SUBJECT: Entergy Nuclear Operations, Inc.
Pilgrim Nuclear Power Station
Docket No. 50-293
License No. DPR-35

License Renewal Application, Amendment 2

LETTER NUMBER: 2.06.049

Pilgrim Nuclear Power Station Drywell Shell Information

PILGRIM NUCLEAR POWER STATION DRYWELL INFORMATION

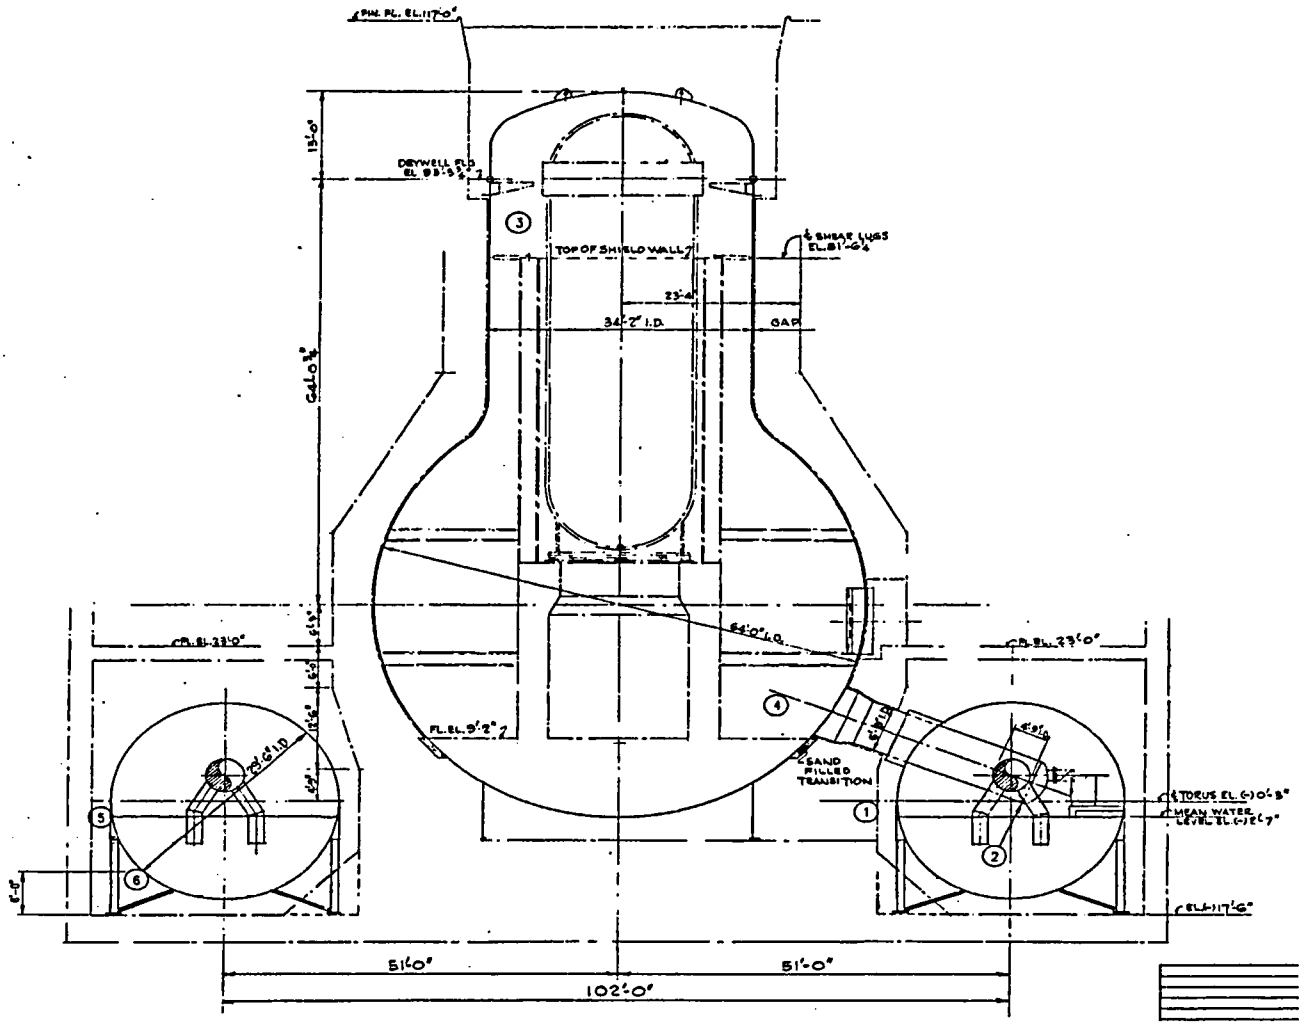
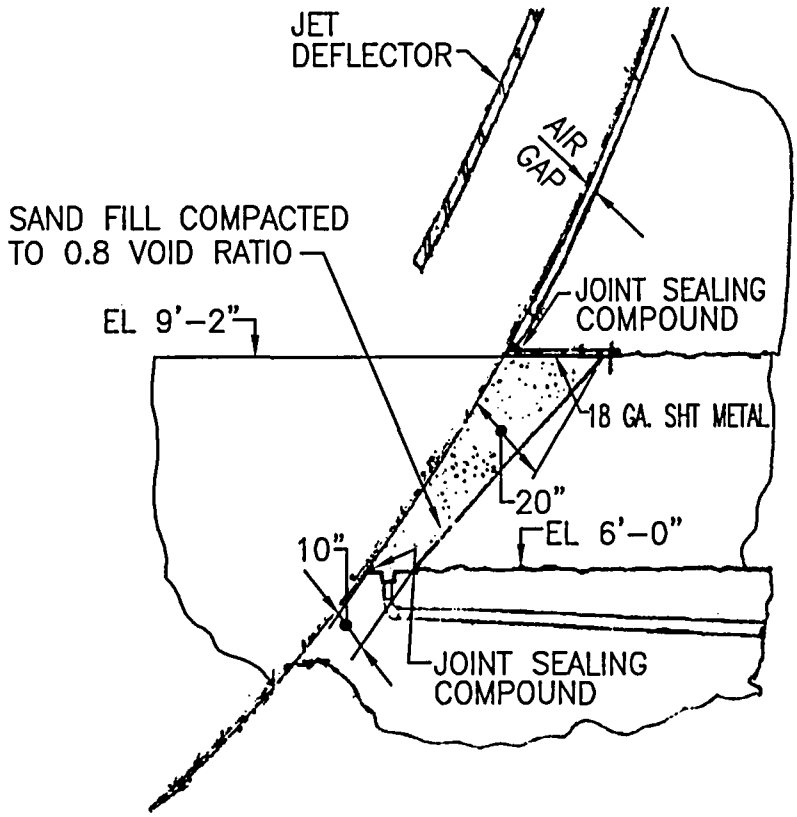
Based on recent discussions between industry and the NRC staff, Entergy provided additional information concerning the drywell shell in the referenced letter. The attachment of this letter provides more detail regarding specific elevations (i.e. addition of inches) in the "Operating Experience and Actions Taken to Prevent Drywell Corrosion" section of the attached information on the drywell shell. For convenience, change bars are included to assist in identifying these specific elevations. Moreover, this letter replaces the figure of the sand pocket (page 6 of 6 of the attachment contained in the referenced letter) with a nearly identical figure that is more legible.
